Staff Report

From: Colin Cortes, AICP, CNU-A, Senior Planner

Meeting Date: September 26, 2019 (Prepared September 19, 2019)

Item: 1800 W. Hayes Street “Nellie Muir Elementary School” (CU 2019-05)

1 ELECTRICAL SITE PLAN - LUR
 SCALE: 1" = 30'

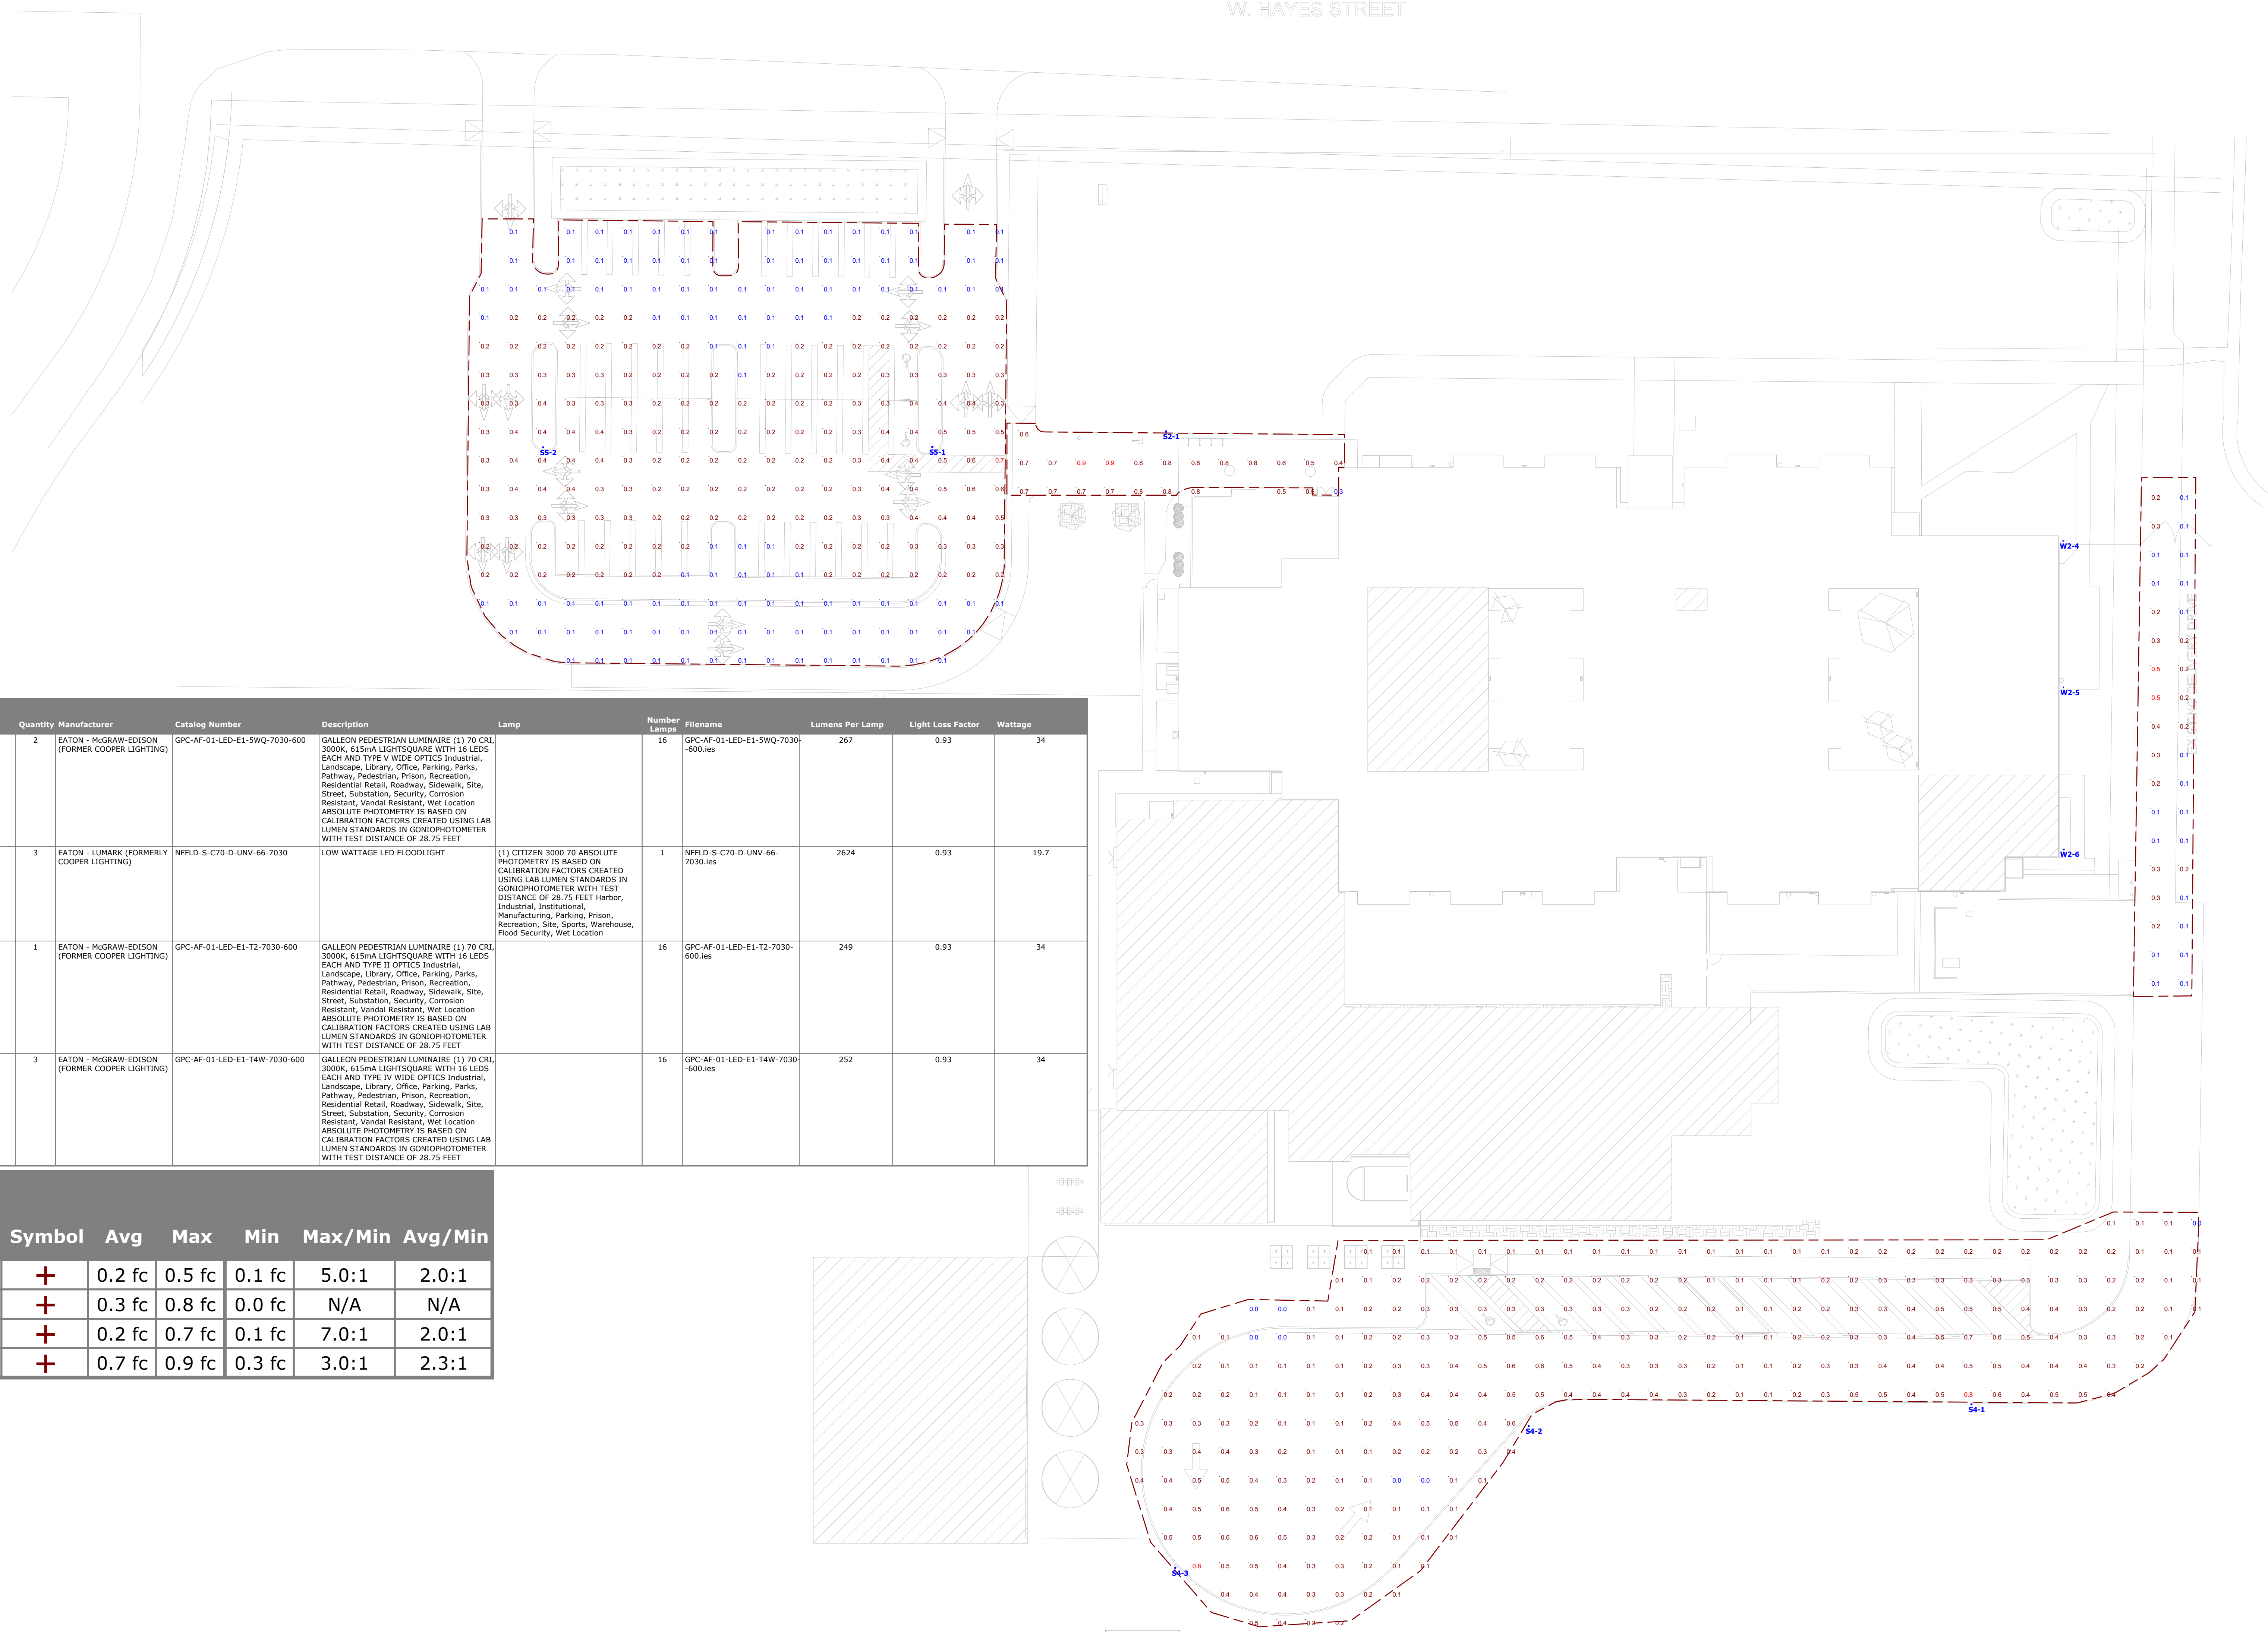
Sheet E.201 Electrical Site Plan – LUR through a diagonal dashed line implies removal of an existing electric power line lateral from the W. Hayes Street power line overhangs the parking area:
